DEVELOPMENT SERVICES

PLAN REVIEW CONDITIONS

February 25, 2022

Permit No: PRCOM20220590
Project Title: MO' BETTAHS
Project Address: 520 NW CHIPMAN RD, LEES SUMMIT, MO 64086
Parcel Number: 241167
Location / Legal Description: SUMMIT ORCHARD LOT 4C-1 4C-2 AND 4C-3 CORRECTED SUMMIT ORCHARD LOTS 4A-4E --- LOT 4C-2
Type of Work: NEW COMMERCIAL
Occupancy Group: ASSEMBLY FOR FOOD AND DRINK INC BARS, RESTAURANTS, BANQUET HALLS
Description: NEW RESTAURANT WITH DRIVE-THRU

ONE-LINE DIAGRAM - NORMAL
NOT TO SCALE

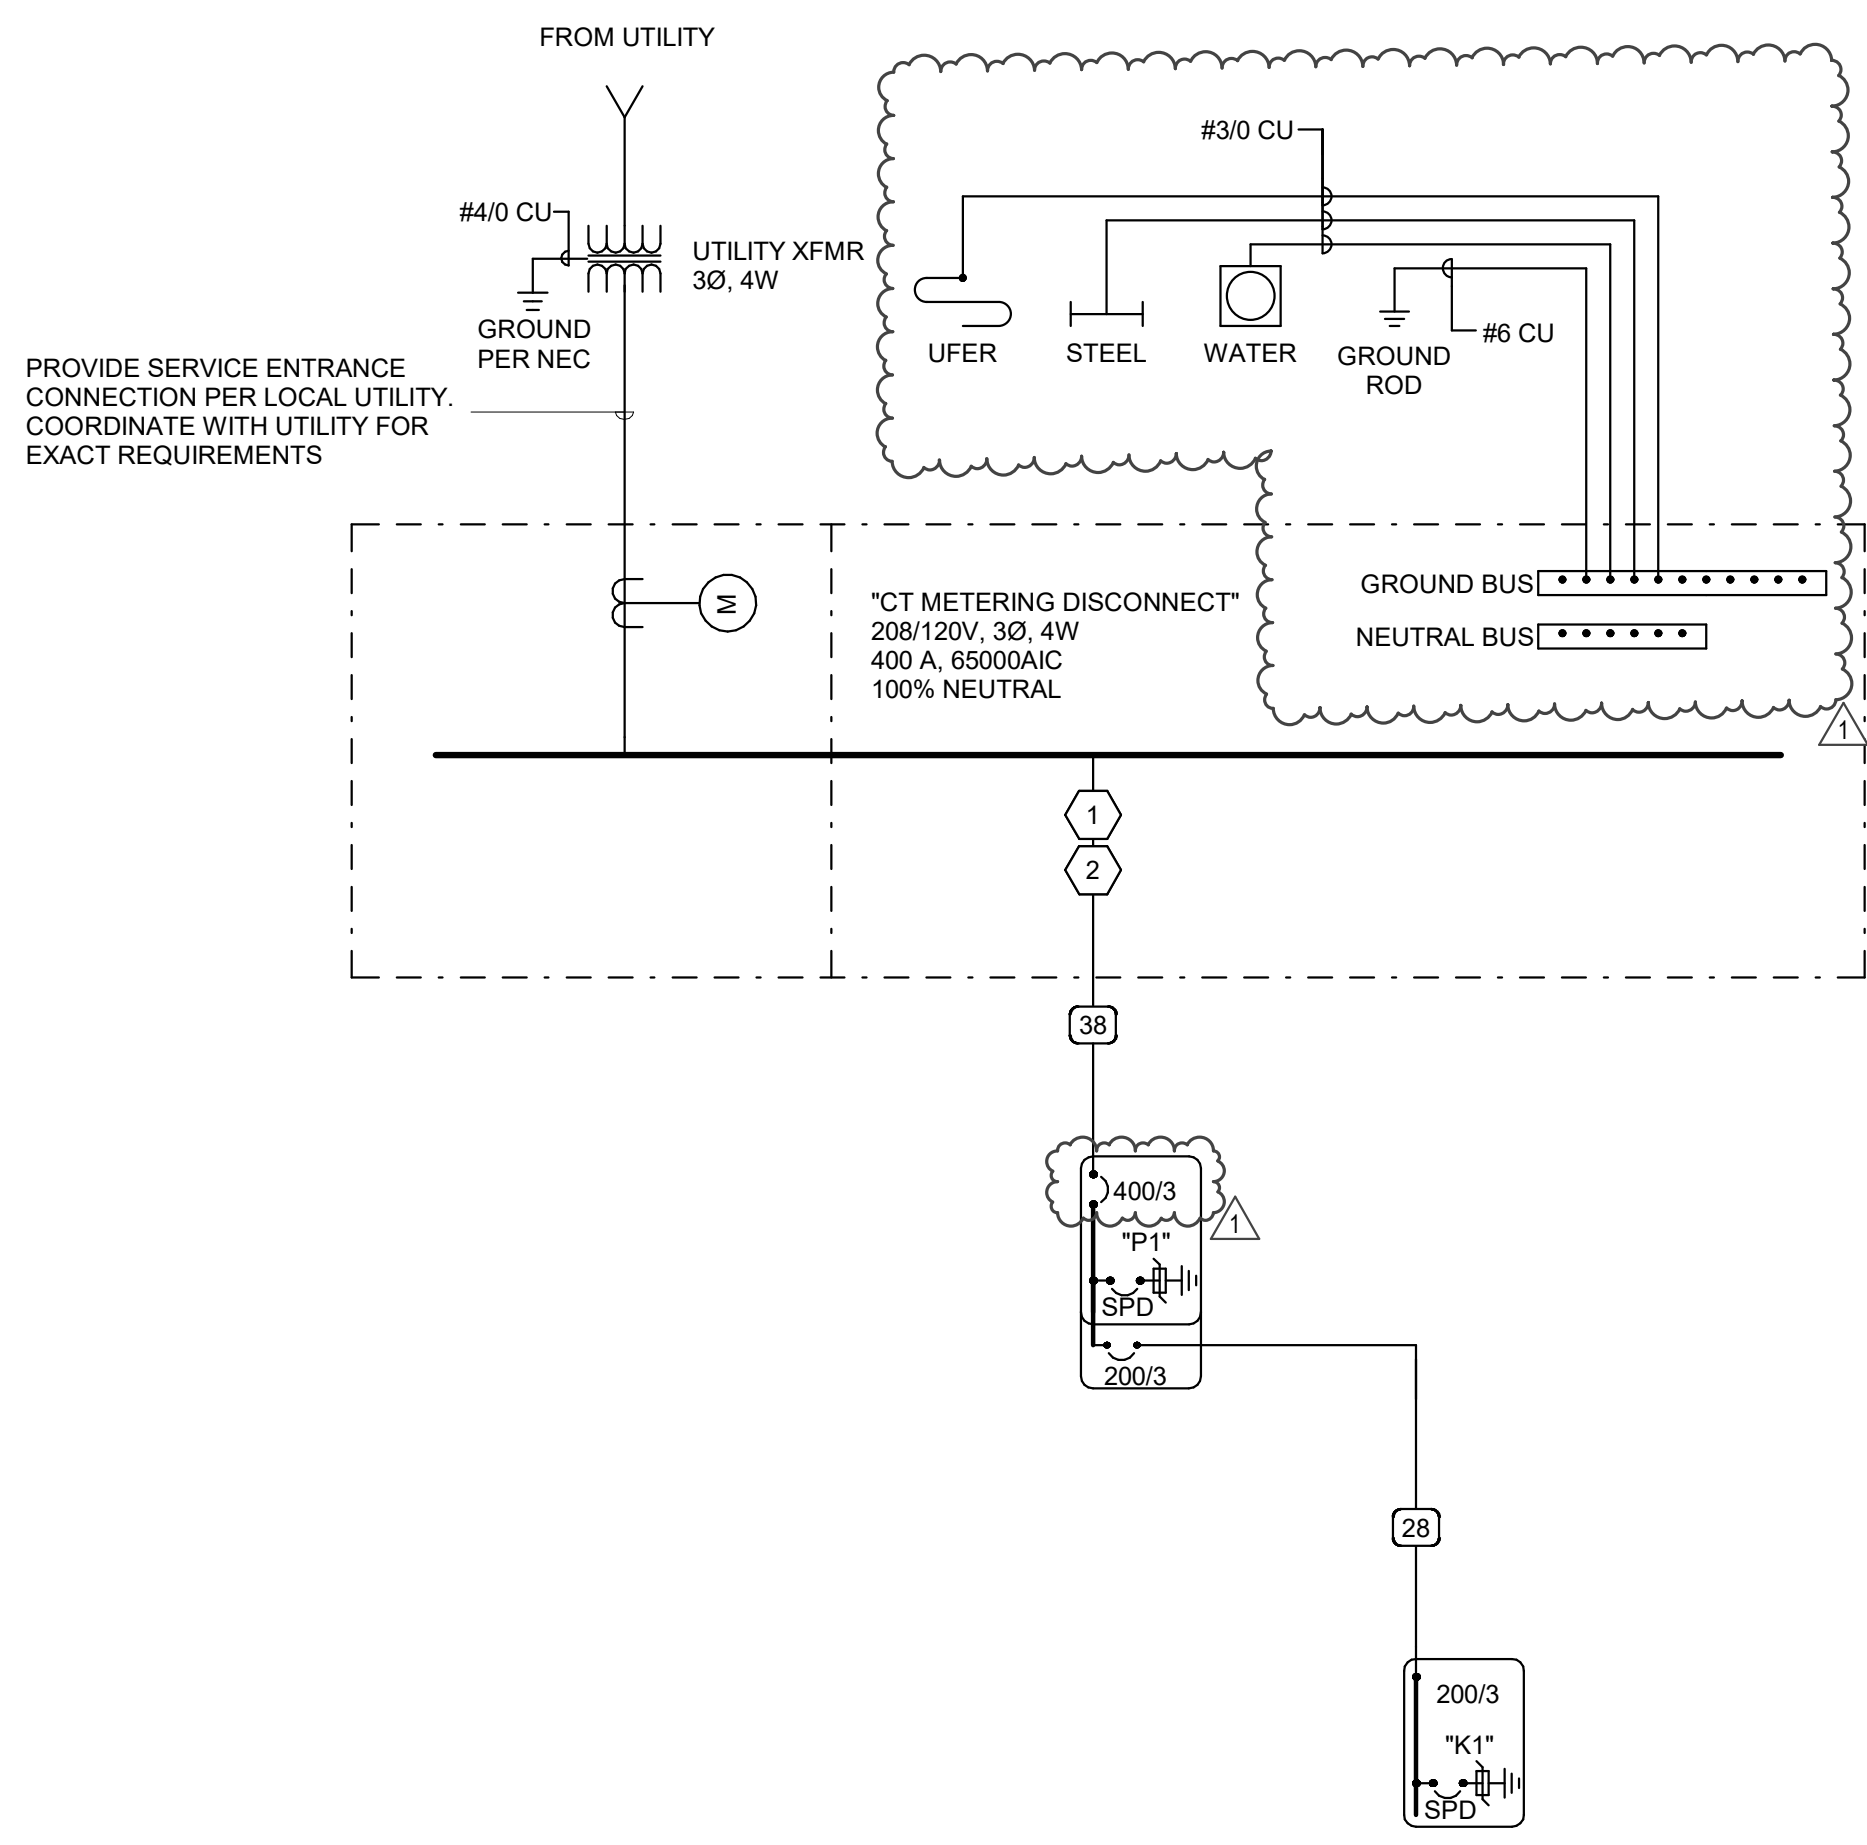
8. 2017 NEC Article 250.50 Grounding Electrode System. All Grounding electrodes as described in 250.52(A)(1) through (A)(7) that are present at each building or structure served shall be bonded together to form the grounding electrodes system. Where none of these grounding electrodes exist, one or more of the grounding electrodes specified in 250.52(A)(4) through (A)(8) shall be installed and used. (see code section for exception)

Action required: Provide complete diagram for grounding scenario at service disconnect.

Response: See updated sheet EP601 showing the revised one-line diagram with the ground bus connections.
